DESCRIPTIVE REPORT (HYDROGRAPHIC)

Type of Survey Hydrographic
Field No. FA-20-1-78
Office No..... H-9752

State California
General Locality Santa Barbara Channel
Locality Punta Gorda to Santa Barbara Point

DESCRIPTIVE REPORT
TO ACCOMPANY
HYDROGRAPHIC SURVEY H-9752 (FA-20-1-78)
NOAA SHIP FAIRWEATHER S220

10. Reference section VII-A of the Verifier's Report:

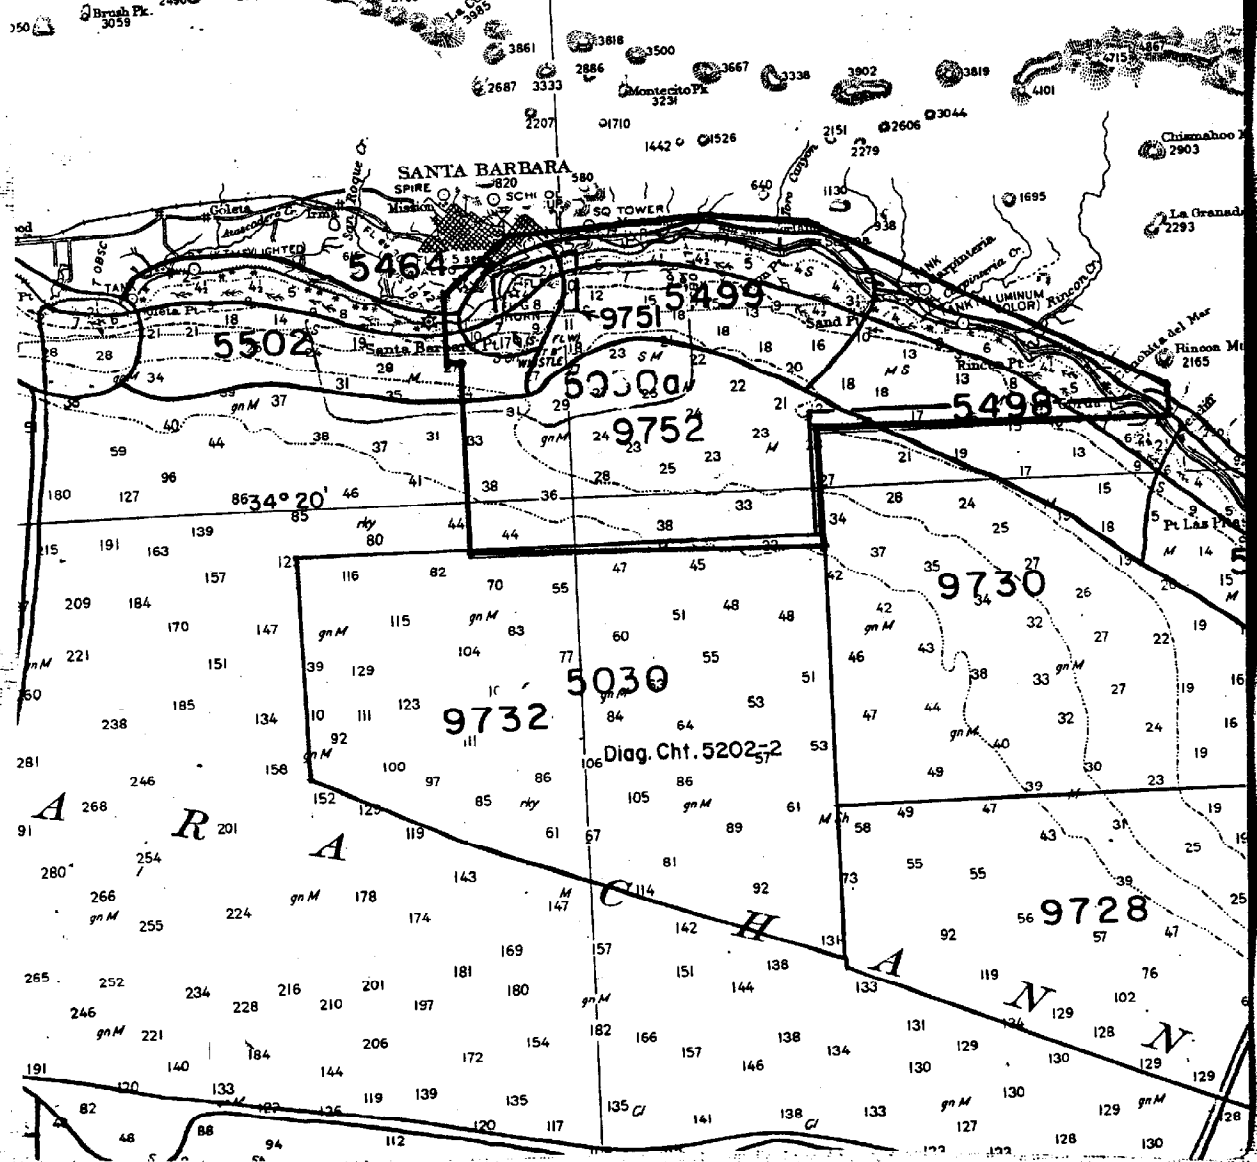
Numerous charted rocks are addressed in the referenced section of the Verifier's Report. During verification, the rocks were designated as originating with unknown sources. During quality control inspection, most of the referenced rocks were determined to originate with the prior surveys and were appropriately carried forward to supplement the present survey. A careful examination of the prior surveys during verification should have provided the sources of the referenced rocks thereby facilitating their transfer to the present survey. This would have obviated the need for enumerating the referenced rocks in the Verifier's Report as well as time-consuming consideration during quality control inspection.
